### City of Phoenix

#### Staff Report Z-61-20-8 and Z-62-20-8 March 4, 2021

Request To (Z-62-20-8):	C-1 DNS/WVR SPVTABDO (Neighborhood Retail, Density Waiver, South Phoenix Village Target Area B Design Overlay District) (2.50 acres)
Proposed Use:	Single-family attached residential
Location:	Northeast corner of 16th Street and Chipman Road
Owner / Applicant:	Ran Edelman

Conceptual Site Plan with Planning and Development Department annotations,  
Source: A/E Design

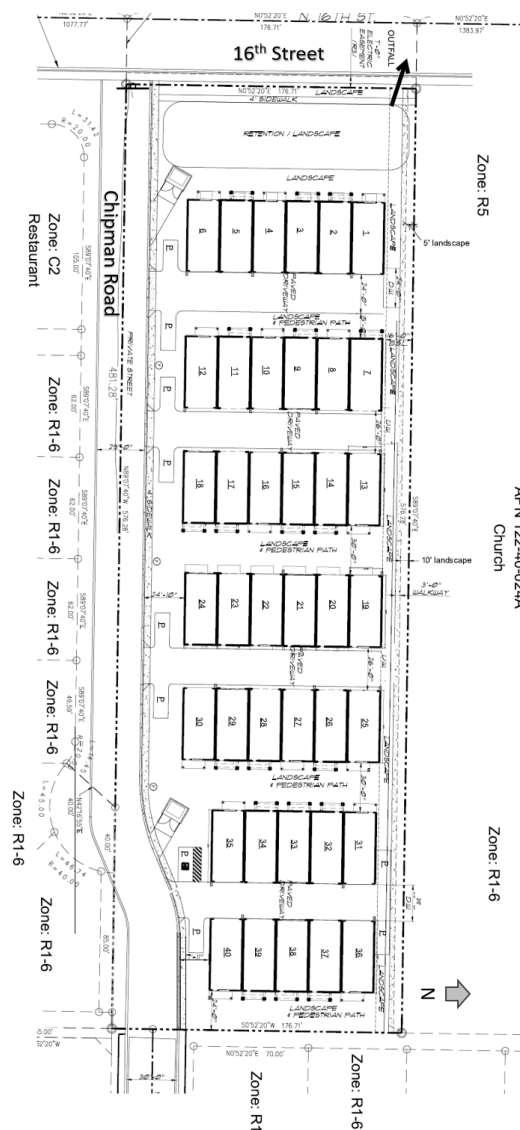
The applicant is proposing 40 single-family attached residential dwellings, with both two- and three-bedroom units, across seven residential buildings oriented east to west. All of the proposed buildings will be two stories, under 30 feet in height. Access to the subject site is proposed along Chipman Road, to be dedicated as a public street, although the applicant has proposed a private accessway along Chipman Road connecting both 16th Street along the west and 17th Street to the east.

Vehicular access to individual units is proposed through shared driveways that connect Chipman Road to the garages of each residential unit, where two parking spaces will be located. Pedestrian access is proposed along the front of each unit, which is oriented to an open space area.

Staff is recommending Stipulation No. 1 in case Z-62-20-8, requesting the density waiver, limiting the maximum number of dwellings to 40 units, to promote compatibility with adjacent residential uses and various residential densities permitted via the zoning districts in the general area. The stipulated density would permit two additional dwelling units beyond R-3 zoning district standards.

General conformance to the conceptual site plan is not proposed since zoning variances are intended to be applied for by the applicant following the rezoning process to address encroachments into required landscape areas by parking stalls and trash enclosures. In addition, single-family attached is subject to a use permit when located within the development option area. Use permit and variances undergo a separate review process, subject to the discretion of the Zoning Adjustment Hearing Officer.

Conceptual Site Plan 4837 S 16th St Phoenix  
South Mountain Shadows - Single Family Attached development  
APN 122-46-015

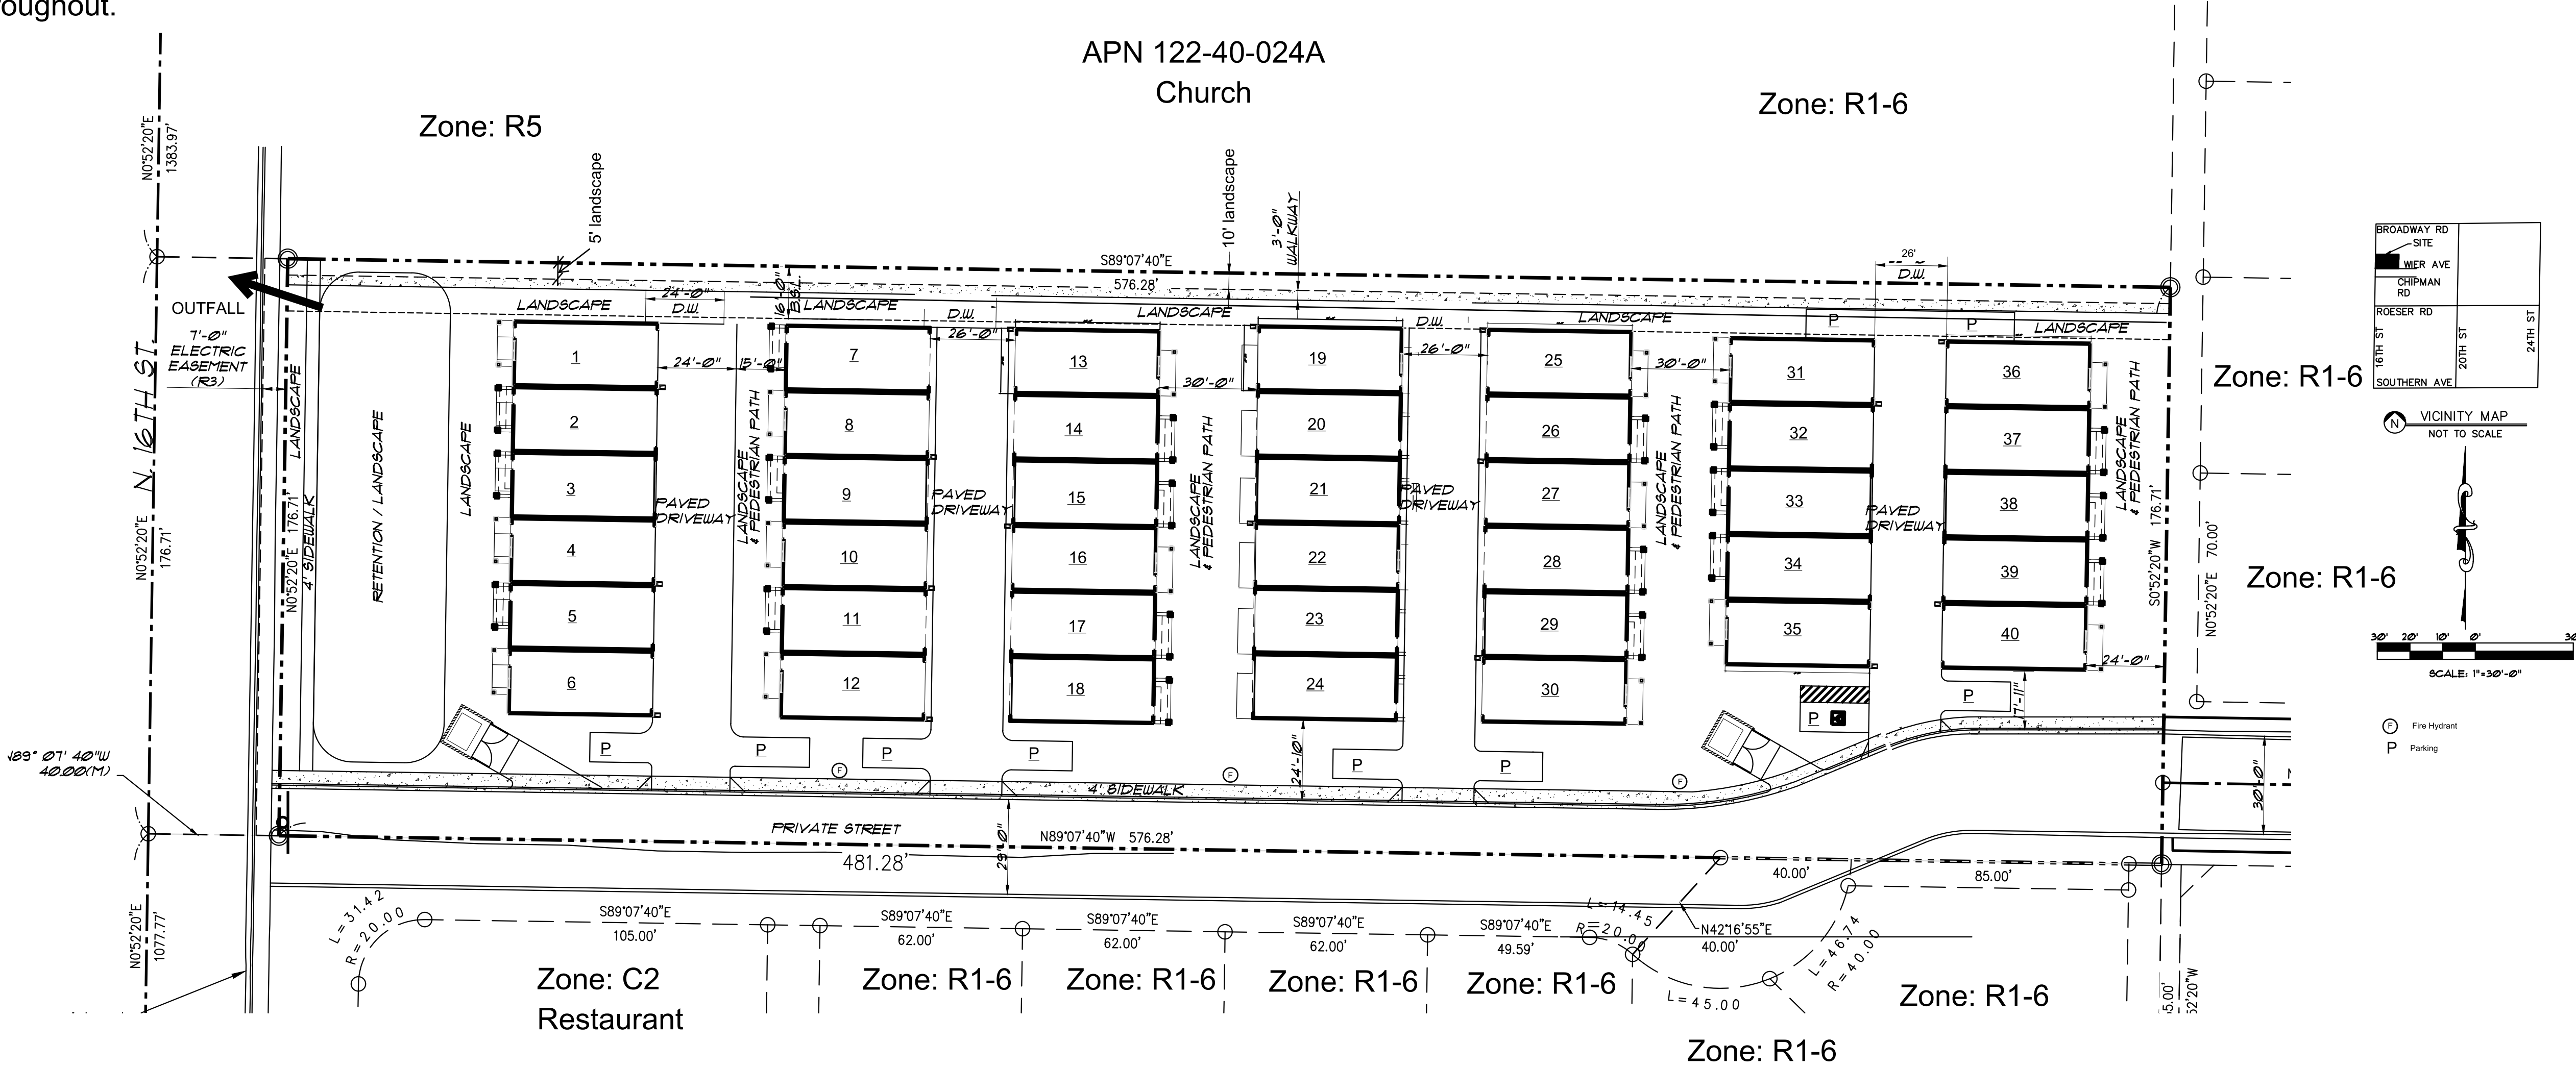
Residences that side an arterial, collector, or local street rights-of-way	Chipman Road (South): 15 feet	<p>Chipman Road: 17 feet (Met)</p> <p>(Trash enclosures and parking stalls are typically not permitted within landscape setbacks as shown in the conceptual site plan)*</p>

\*Site plan revision or variance required.
